Responses to Questions SMGMN-0106 Trash Compactors

These are the responses to questions for the RFP SMGMN-0106 Trash Compactors.

02 TRASH / RECYCLE ROOM
1/8" = 1'-0"

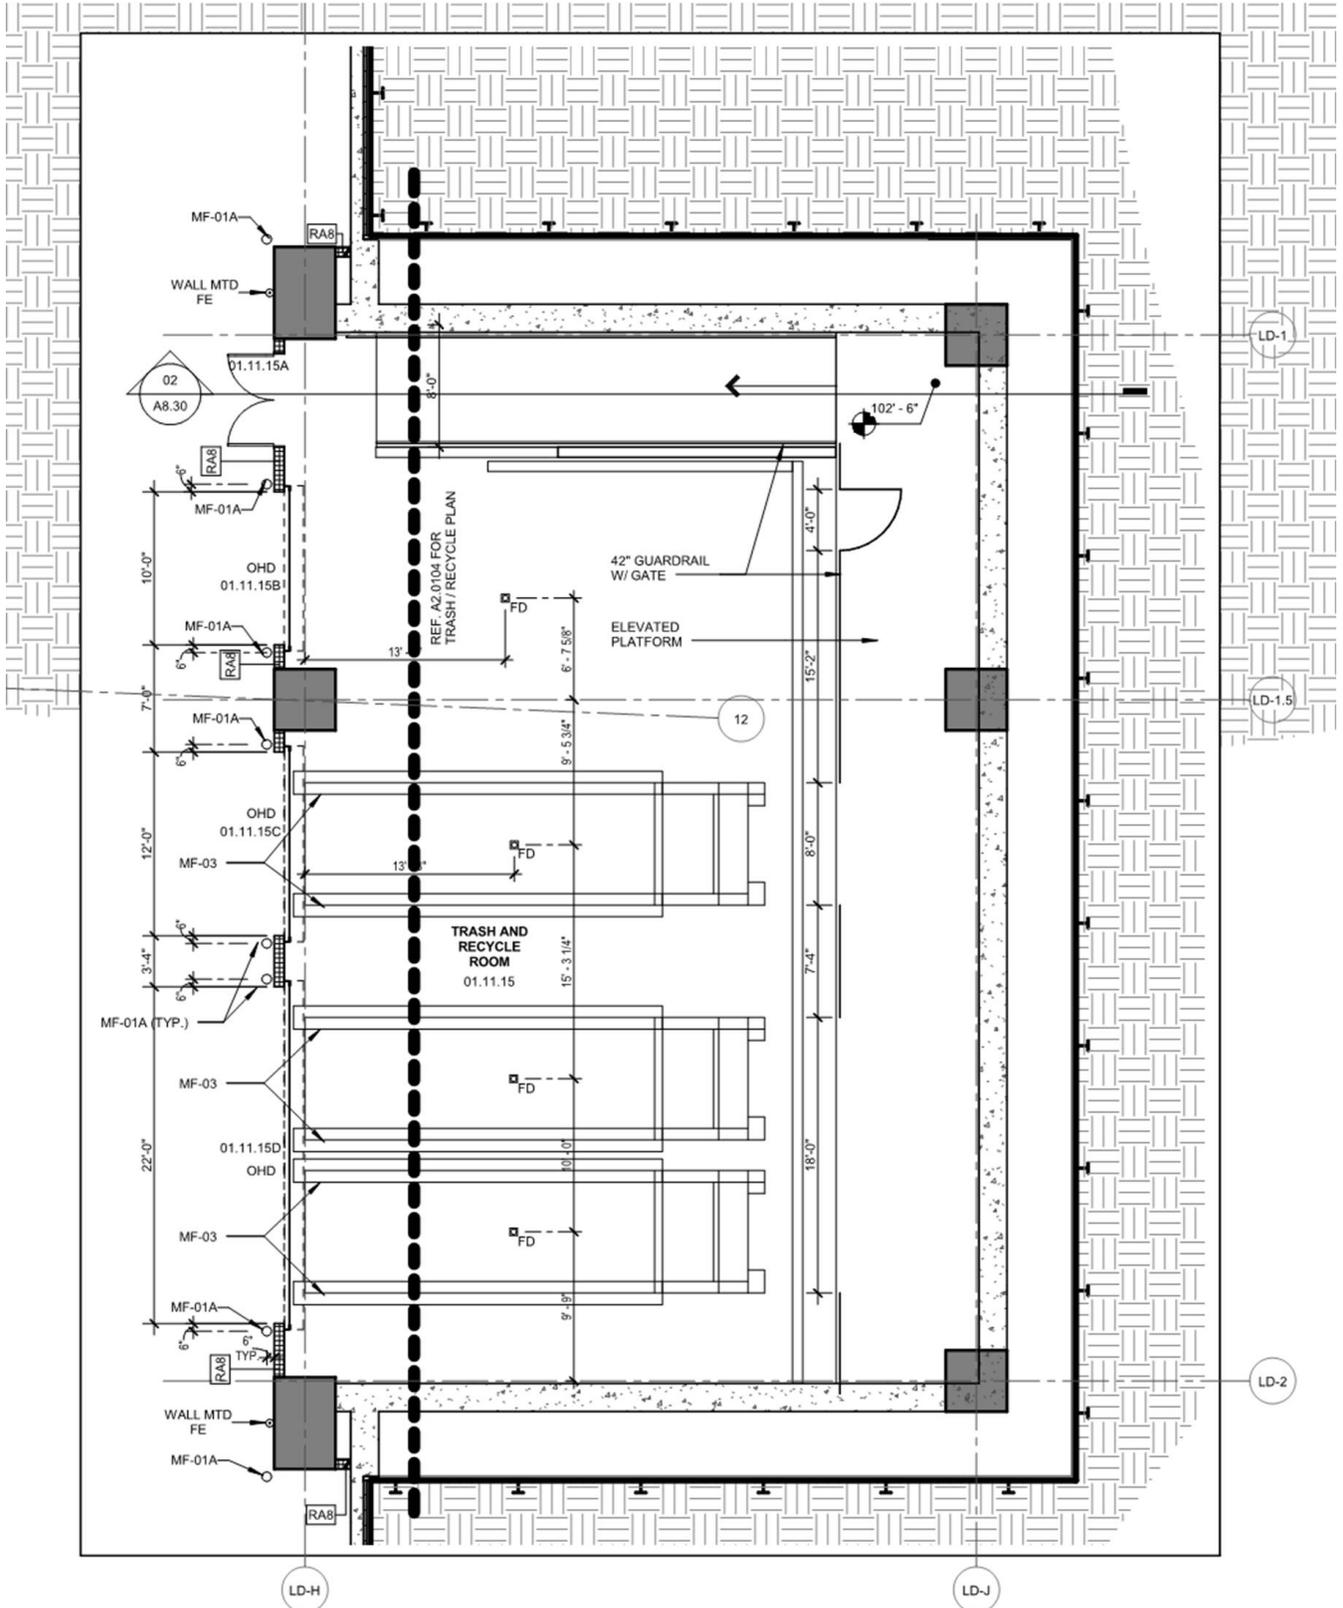
Who is responsible for the railing along the elevated ramp behind the compactors?

Diagram below shows the construction drawing showing railing layout. Guardrails are provided except where the compactors are situated. If there is any requirements for additional railings once the compactors and lifters are installed then contractor will be responsible for making the system OSHA compliant.
